City of Cody Planning, Zoning and Adjustment Board

**City of Cody**  
**Planning, Zoning and Adjustment Board Proceedings**  
**August 6, 2026**

### **Commercial Sign Review for Noir at 1544 Salsbury Avenue and Approval of Resolution PZ 26-33**

### **Downtown Architectural Review for Swelk, LLC at 1314 Sheridan Avenue and Approval of Resolution PZ 26-34**

SHEET #  
C1.0  
SITE PLAN

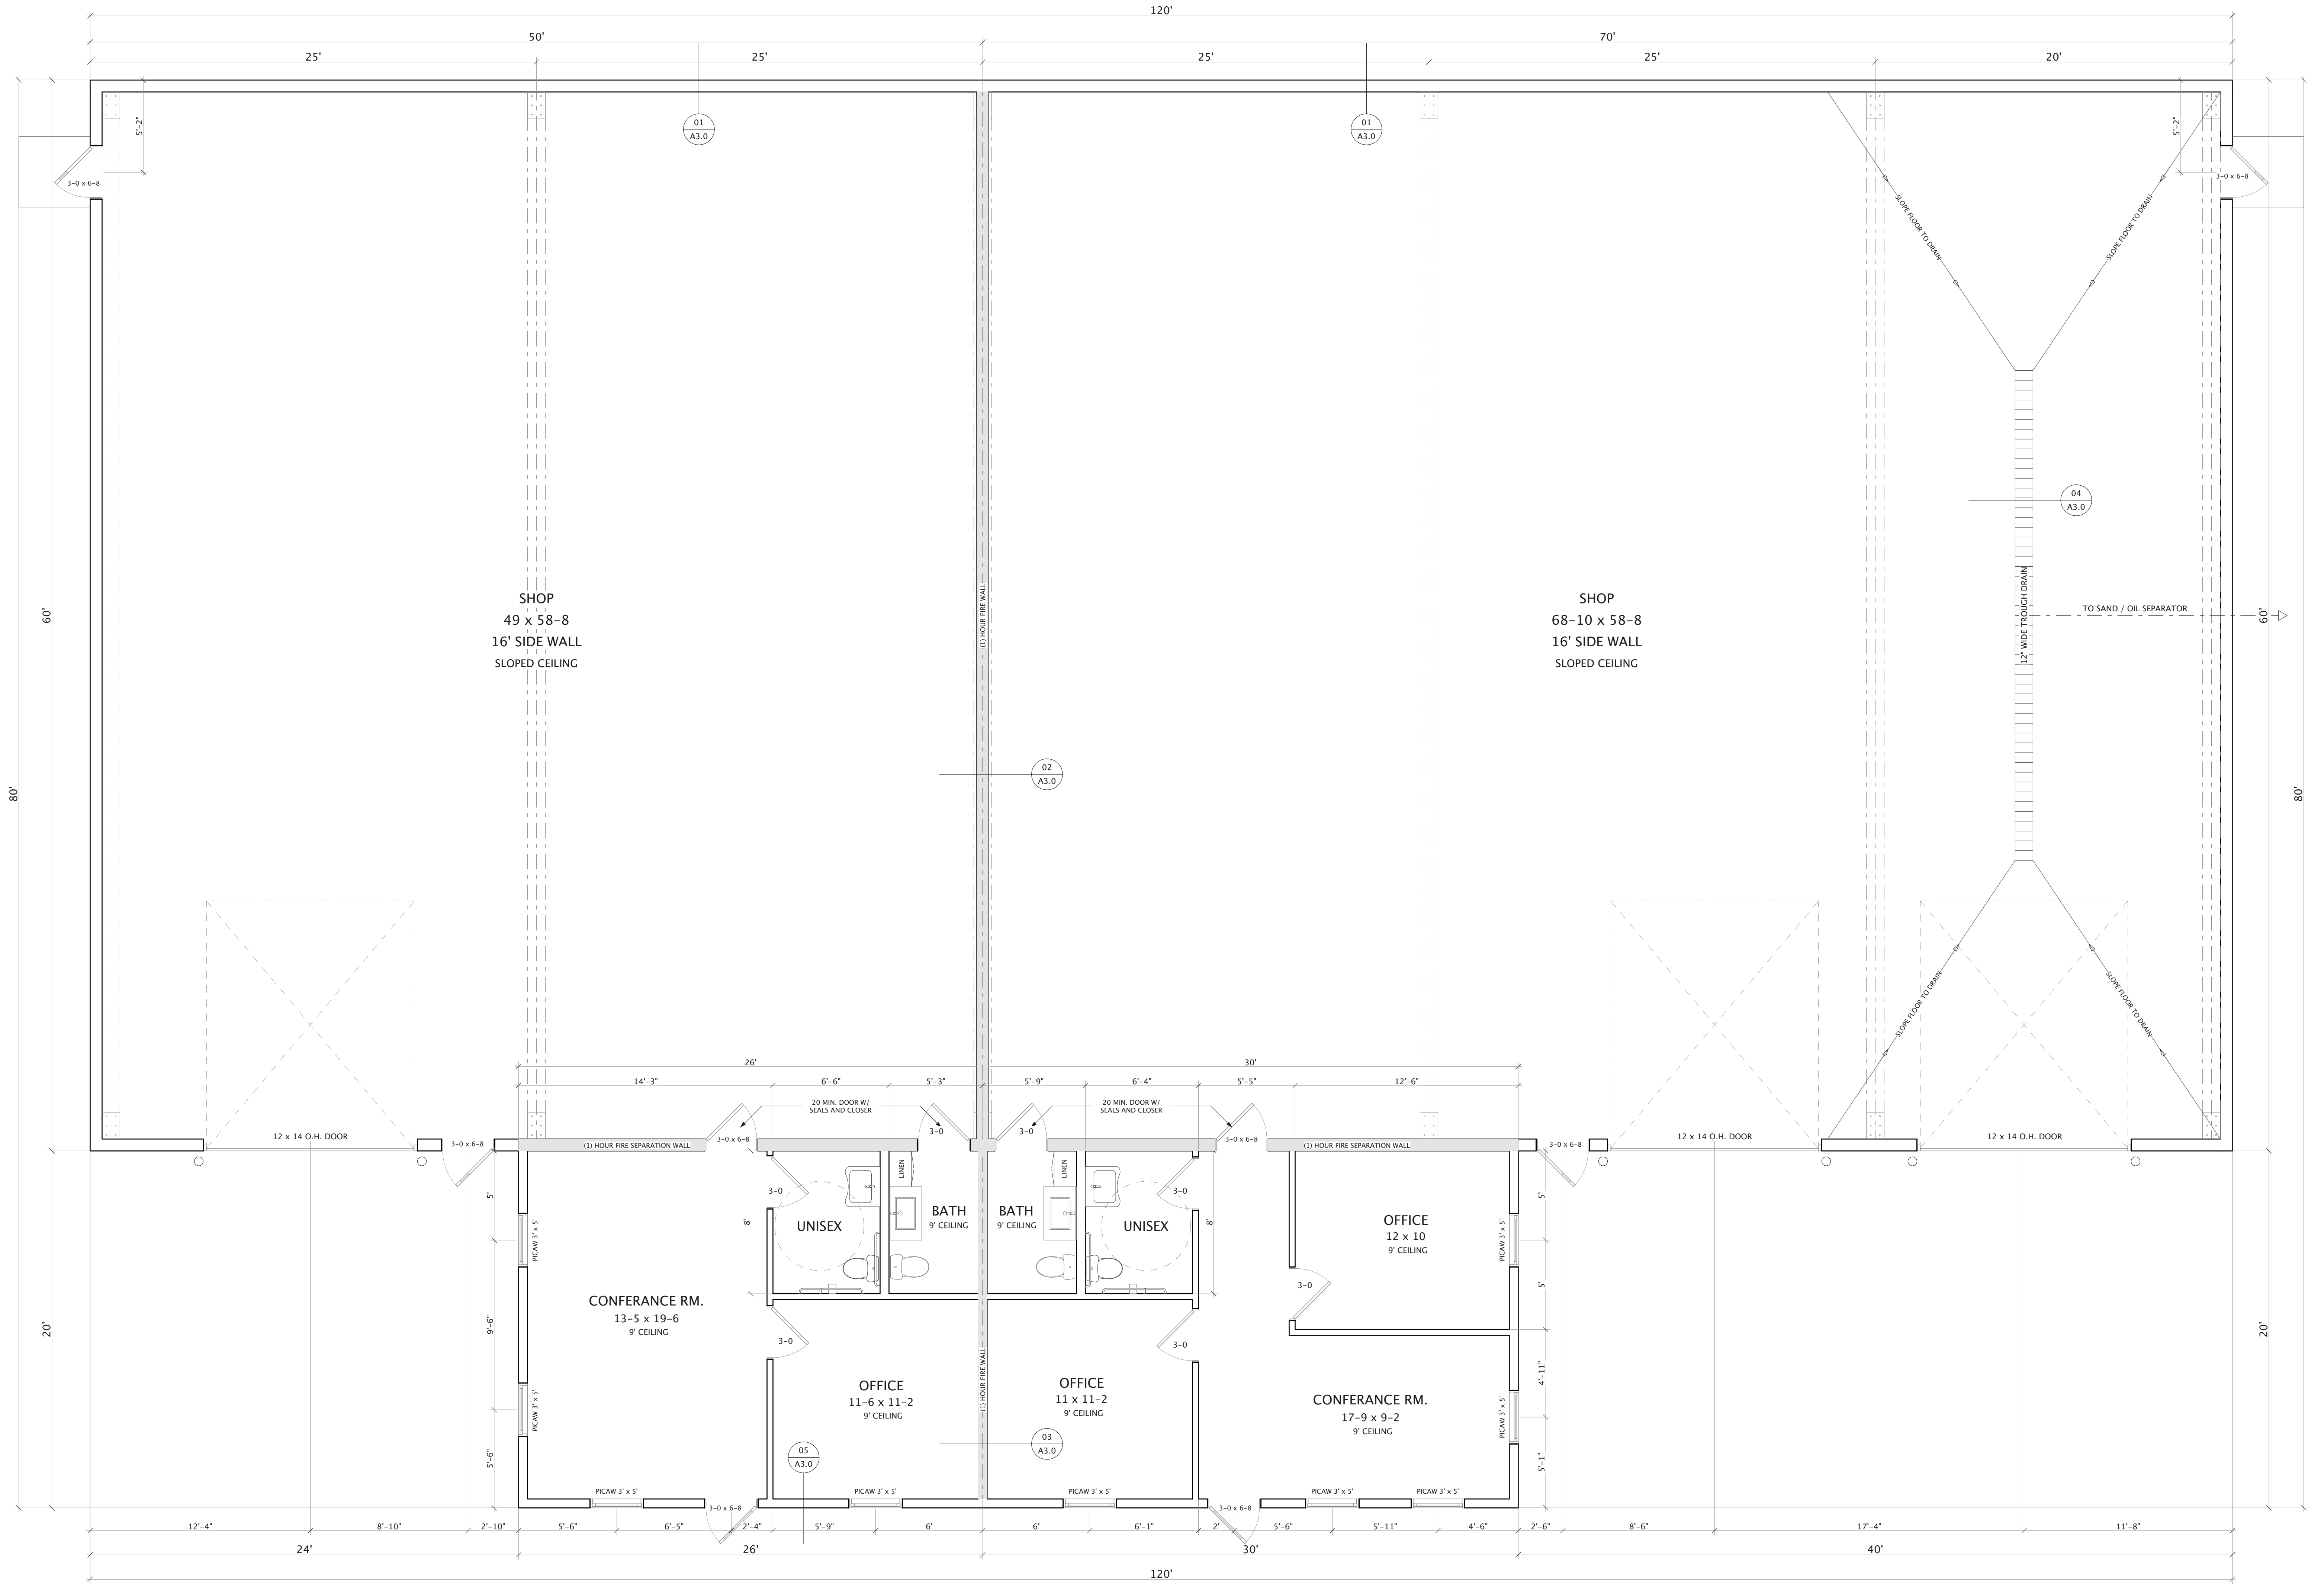
Exterior lighting locations are shown on sheet C1.0 of the site plan. The fixture is shown to the right. Specifications are provided and the lighting exceeds the current City lighting standards. The applicant is seeking an exception from City Council to allow the lighting because they feel it is required for safety of the building lessees and their customers or employees. The lights are full cutoff and down directed. A depiction of the fixture is shown to the right.

LED Soffit lighting is also proposed as shown to the right and on the site plan, to be installed in front of the office entrances. The specifications for these fixtures also slightly exceed the City code and will also require a City Council exception, or an alternative fixture that meets code to be installed.

Two snow storage areas are shown on the site plan; one in the northwest corner and one in the southwest corner.

4. An approved lighting exception from City Council will be required before the proposed lighting is installed, or if the exception is denied by Council, the applicant shall provide a code compliant lighting plan to the planning department for staff review and approval prior to installation of lighting;
